# Awel y Môr Offshore Wind Farm

## Applicant's Response to Marine Licence Application Consultation Comments

### Deadline 3a

Document Reference: 3a.14

FIGURE NUMBER:  
**Figure 1**

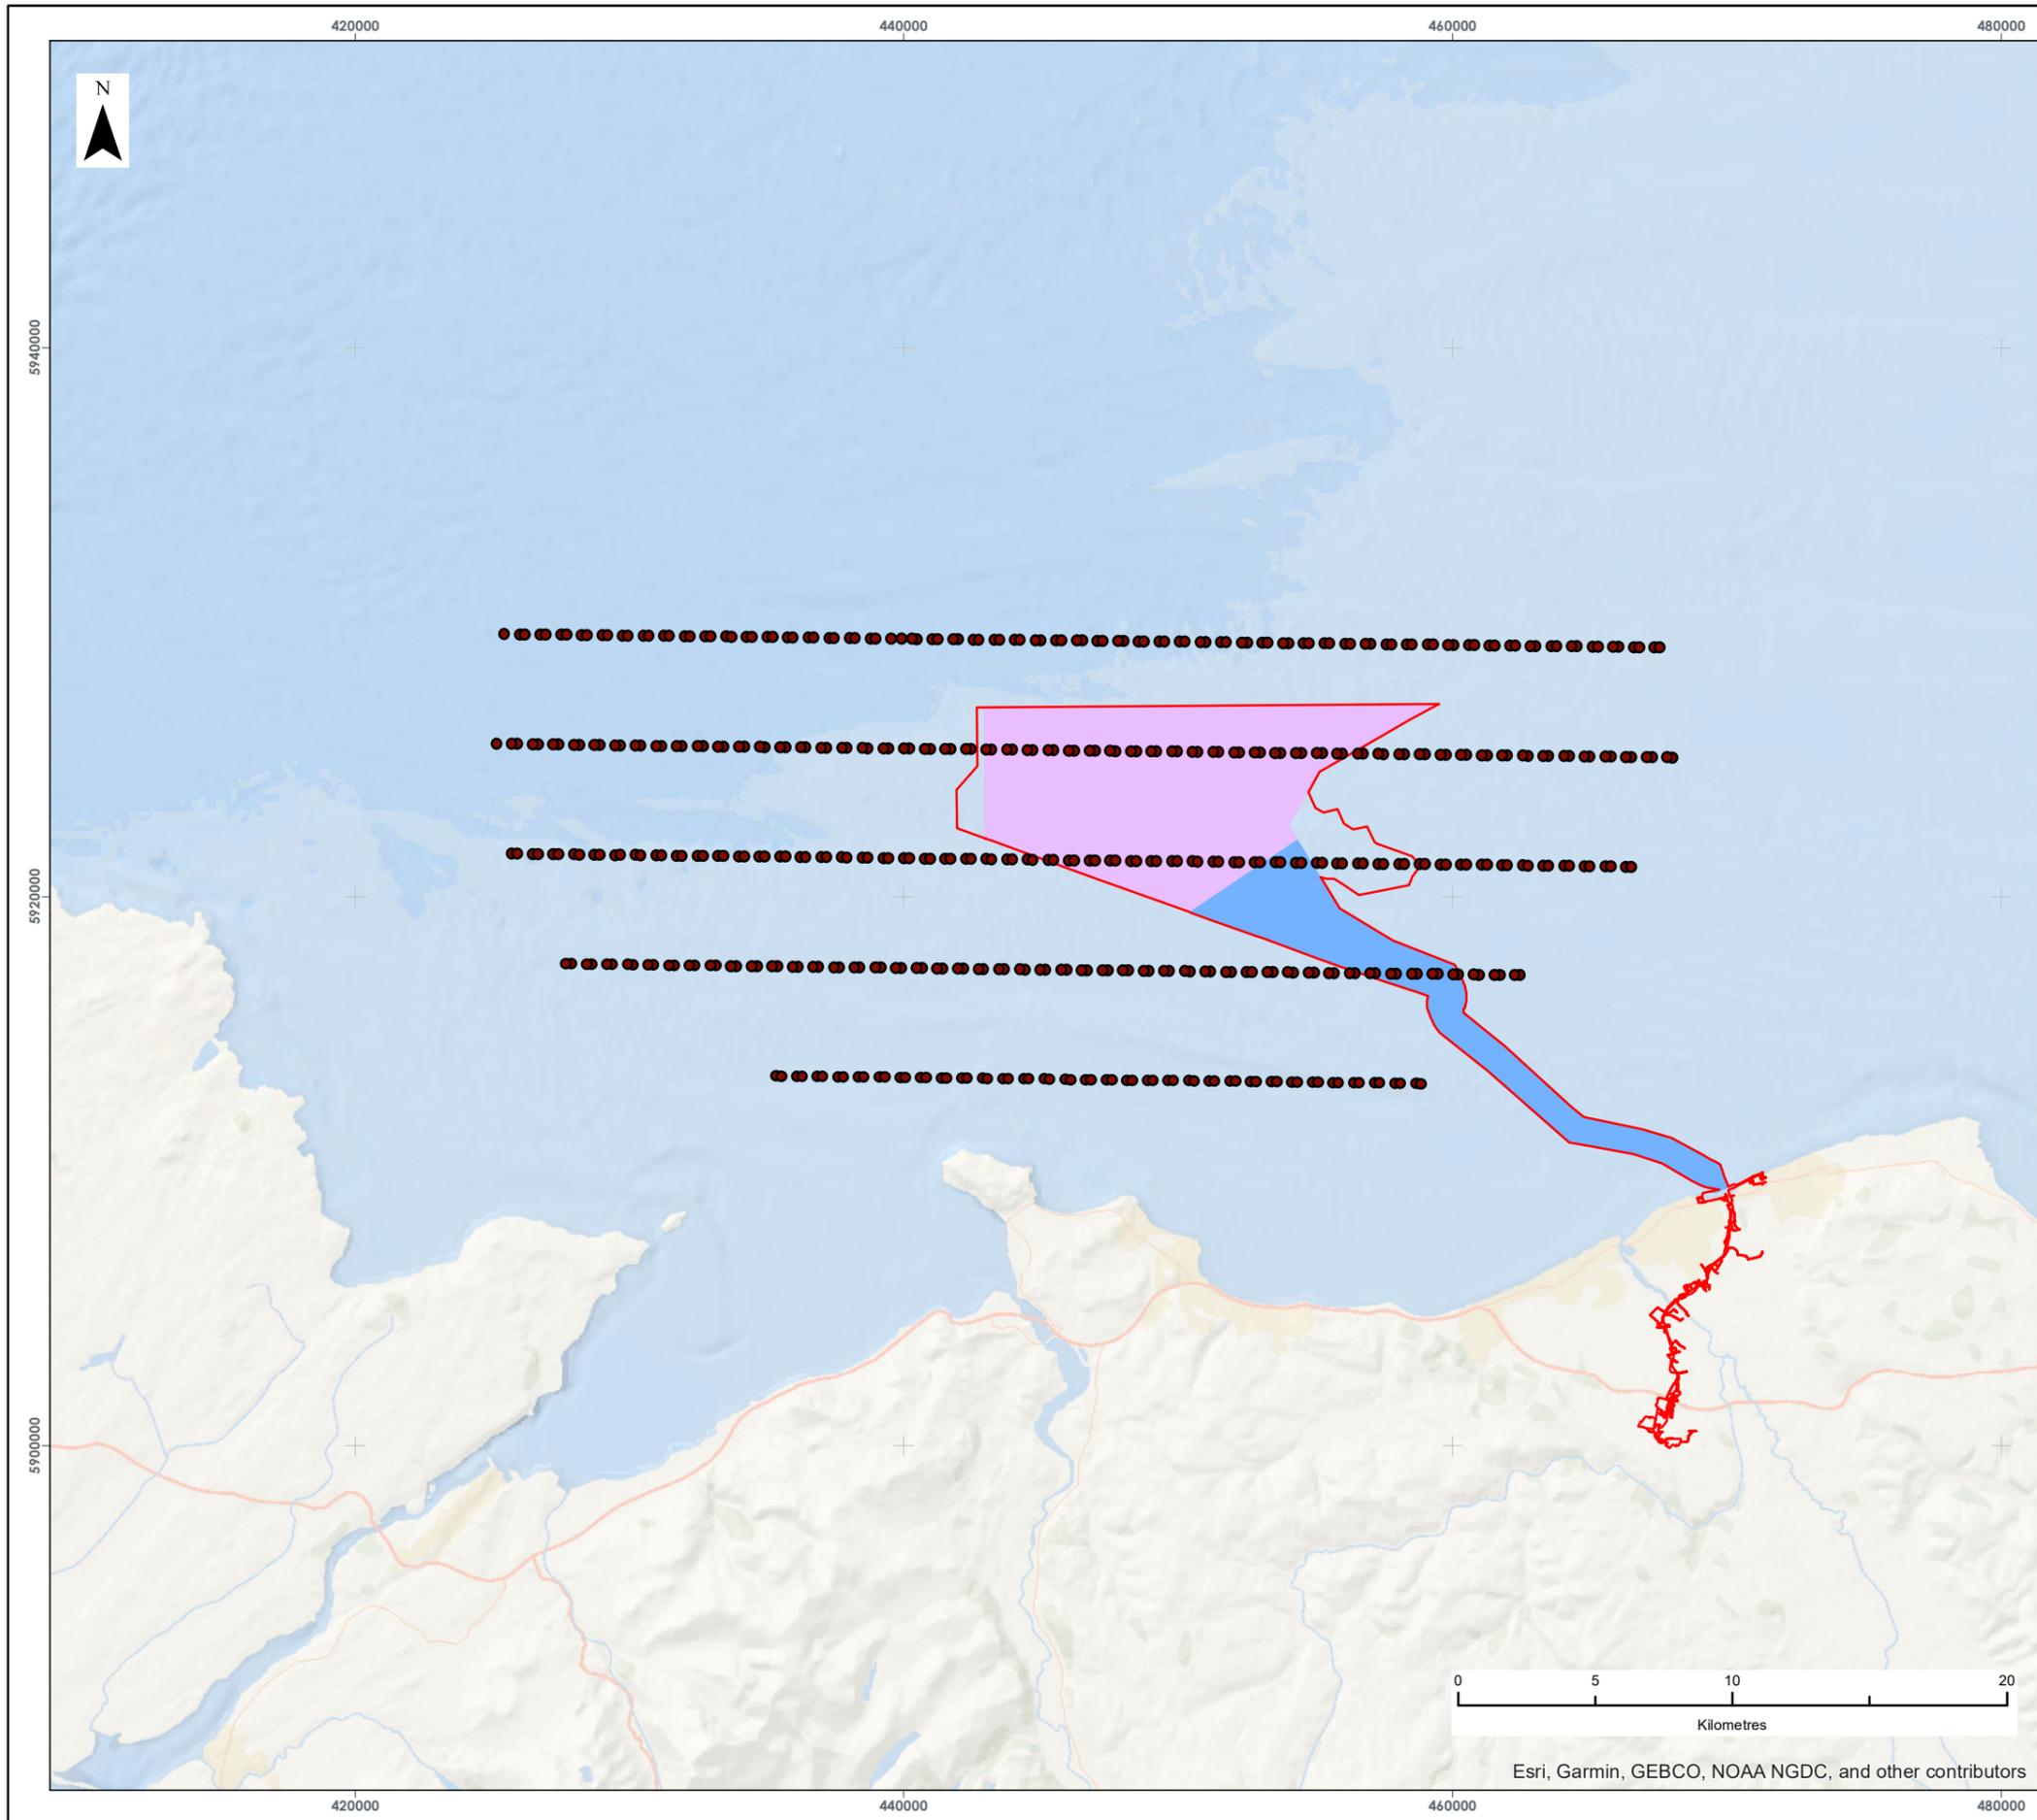
REFERENCE	STAKEHOLDER COMMENT	APPLICANT'S RESPONSE
ML-NRW(A)-7.75	We note the commitment by the Applicant to produce and implement a Vessel Traffic Management Plan in consultation with NRW (A). Whilst it appears that this relates solely to ornithological interests, we recommend that the Plan also appropriately considers marine mammal interests. We advise that such a plan is secured as a condition in the ML.	
ML-NRW(A)-7.76	A number of figures in the revised marine mammal Chapter 7 (6.2.7) appear to be incorrect. For example, Figure 21 is supplied in place of Figure 19, and Figure 21 does not contain all the necessary data layers either time it is presented. Corrected figures should be supplied alongside confirmation of the nature of any revisions from the original version – this will provide NRW (A) with confidence that the revisions and assessments have been applied correctly.	Corrected versions of these figures have been provided to NRW via the DCO examination in the Application Errata List (PINS reference REP1-004). These figures are also provided in Appendix A of this document for completeness.
